# Certificate of Appropriateness

**Property** 1231 E. BRADY ST., Brady St. Historic district  
**Description of work** Install new awning over storefront and signage above awning.  
**Date issued** 4/14/2010  
PTS ID 65049 COA, NEW AWNING AND SIGNAGE

**Cousins Subs**  
new logo awnings

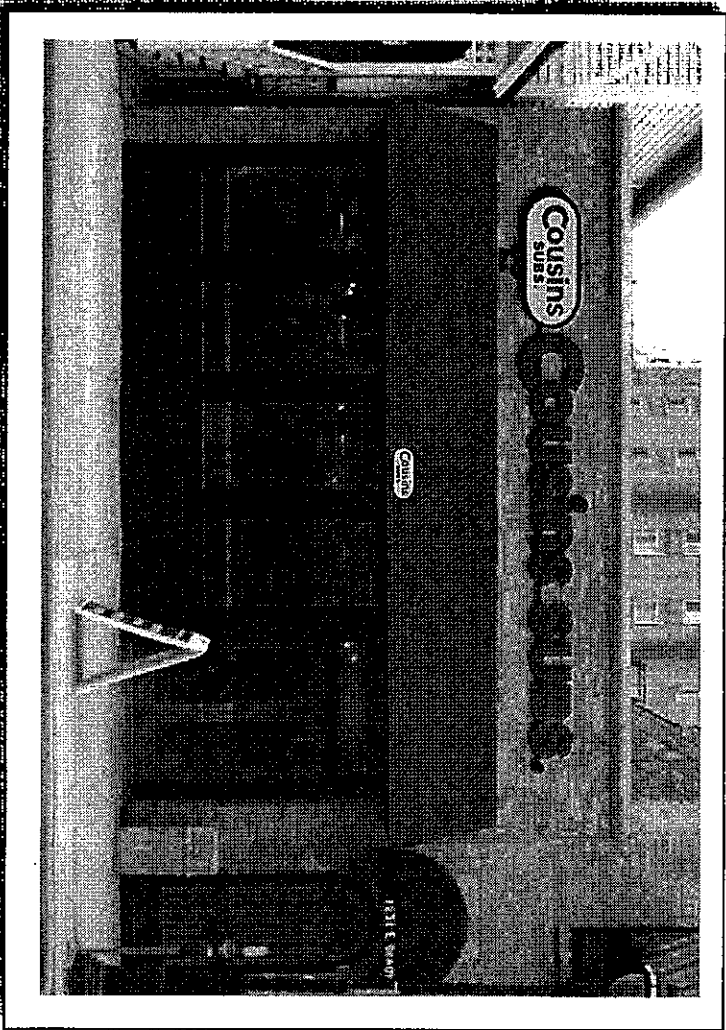
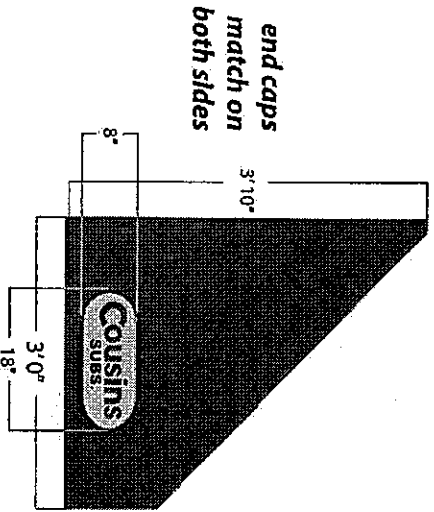
Awning must be of non-shiny material. All signage must be "Type A." "Cousins" logo above awning must be type A, non-illuminated composed of raised letters placed upon lexan face. The raceway upon which the large "Cousins" letters are placed should be painted out to match the color of the brick behind it. Signage on awning will be limited to size and copy presented in the attached drawing.
